CITY of NOVI CITY COUNCIL

Agenda Item 2
November 13, 2018

SUBJECT: Consideration for tentative approval of the request of Keford Collision and Towing, JSP 18-31, with Zoning Map Amendment 18.725, to rezone property in Section 15, located on the south side of Grand River Avenue, east of Taft Road, from I-1 (Light Industrial) to I-2 (General Industrial) with a Planned Rezoning Overlay (PRO) and corresponding Concept Plan. The property totals 7.61 acres and contains two existing buildings. The applicant is proposing to reuse the existing larger building (23,493 square feet) for an auto body collision repair shop and related offices, with accessory car rental services, and use the rear portion of the property as a vehicle tow yard.

Title:
Woodland Plan

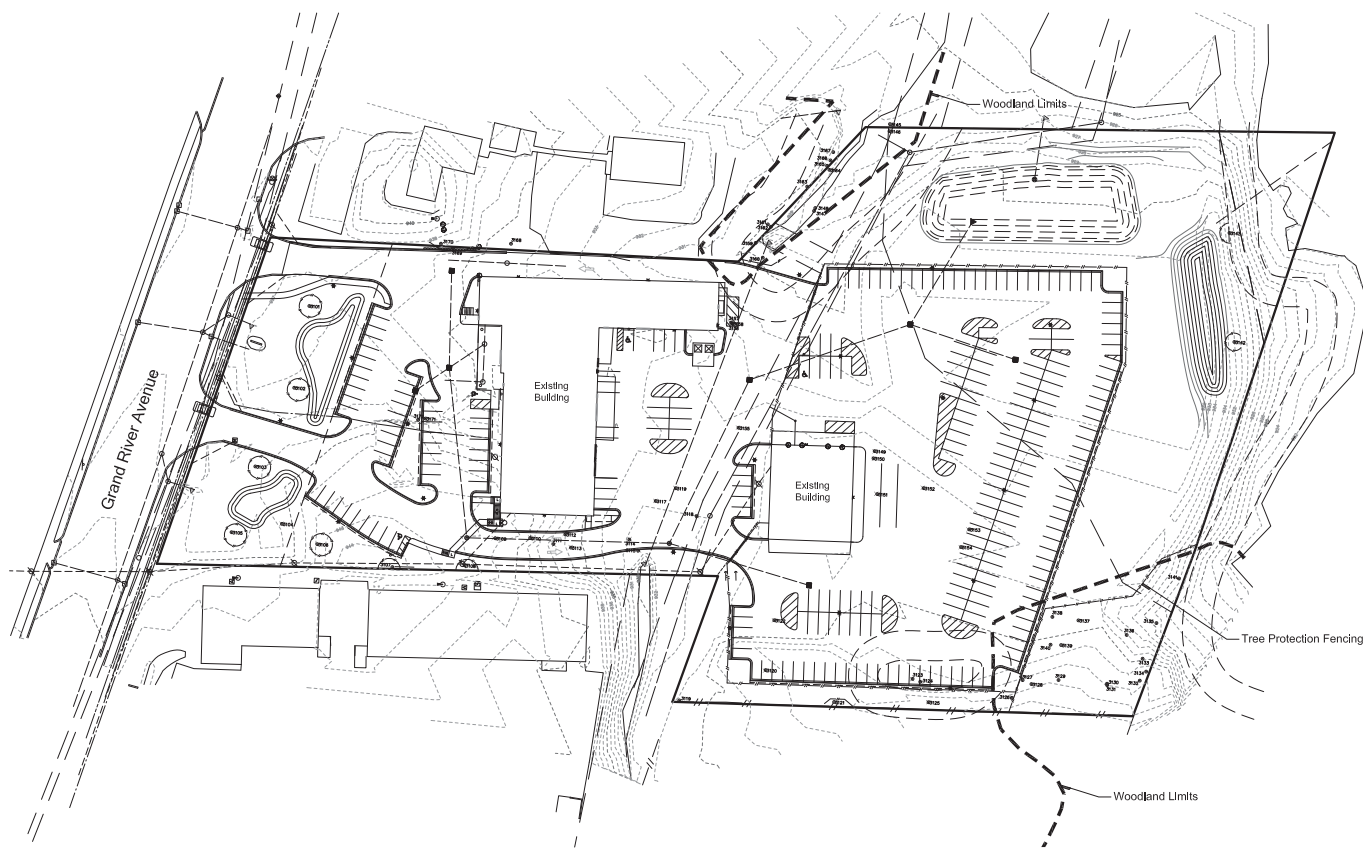
The Woodland Plan (Sheet L-3) indicates that a total of **71** trees were surveyed on the subject site. Of the trees surveyed, thirty-seven (**37**) trees are located outside of the areas mapped as City-Regulated Woodlands. Thirty-four (**34**) of the surveyed trees are located within the City-Regulated Woodland Area.

Figure 1. City of Novi Regulated Wetland & Woodland Map (approximate parcel boundary shown in red). Regulated Woodland areas are shown in green and Regulated Wetland areas are shown in blue.

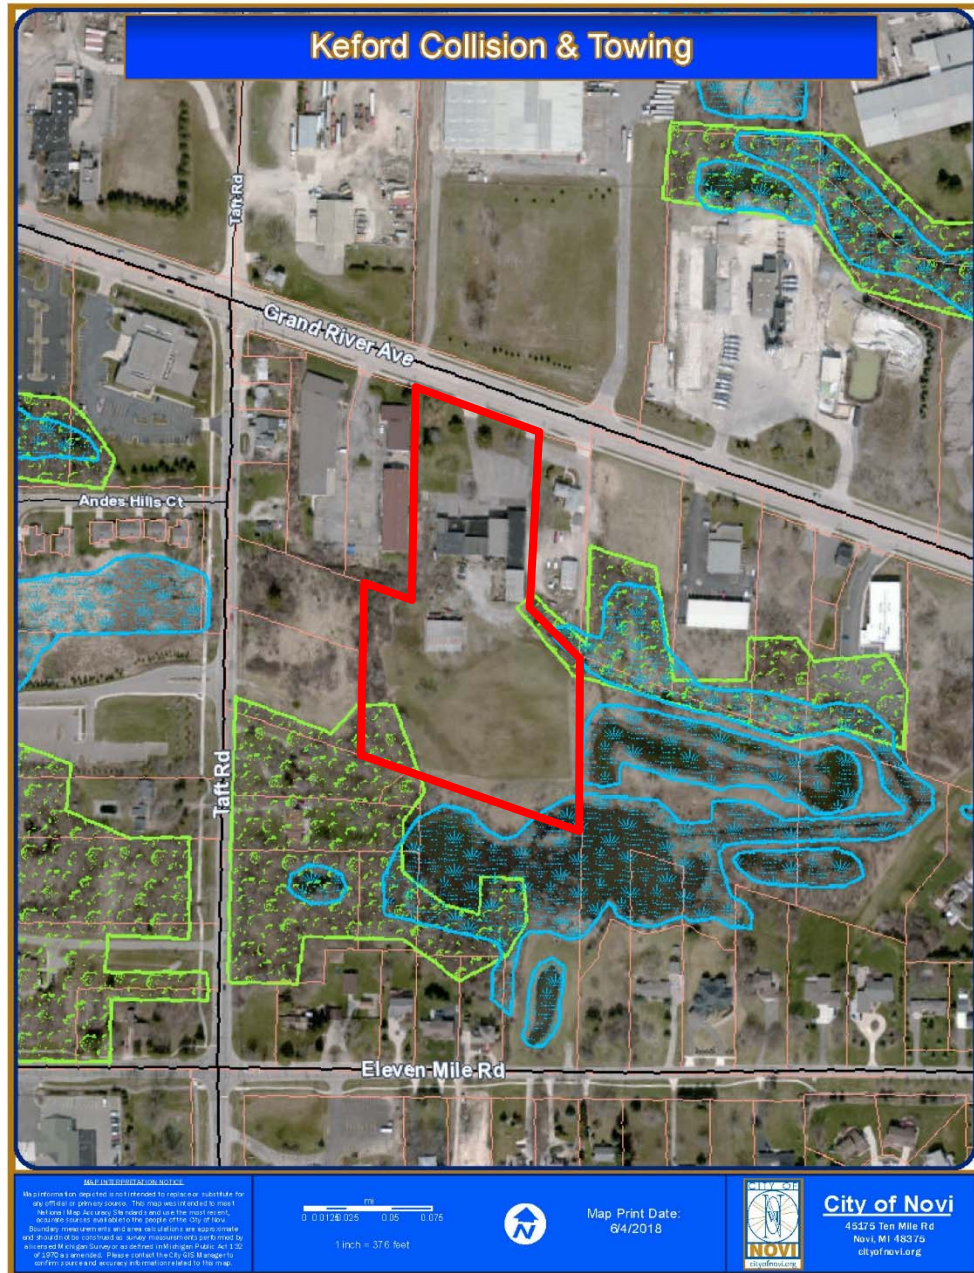
1. The wetland and wetland buffer boundaries indicated on the Plan appear to be approximate. Subsequent site plan submittals shall include the actual, surveyed wetland boundary information that appears to be included on the Wetland Delineation map provided by KME (Figure 2). The wetland flag numbers shall also be provided on the Plan.

2. It is unclear if the proposed site work will impact Wetland C, however it does not appear likely. The boundaries of Wetland C are not currently shown on Sheet 1. This information should be provided/clarified on subsequent site plan submittals.

Response: Additional information will be provided on the Preliminary Site Plan.
Comment: *It is unclear if the proposed site work will impact Wetland C, however it does not appear likely. The boundaries of Wetland C are not currently shown on sheet 1. This information should be provided/clarified on subsequent site plan submittals.*
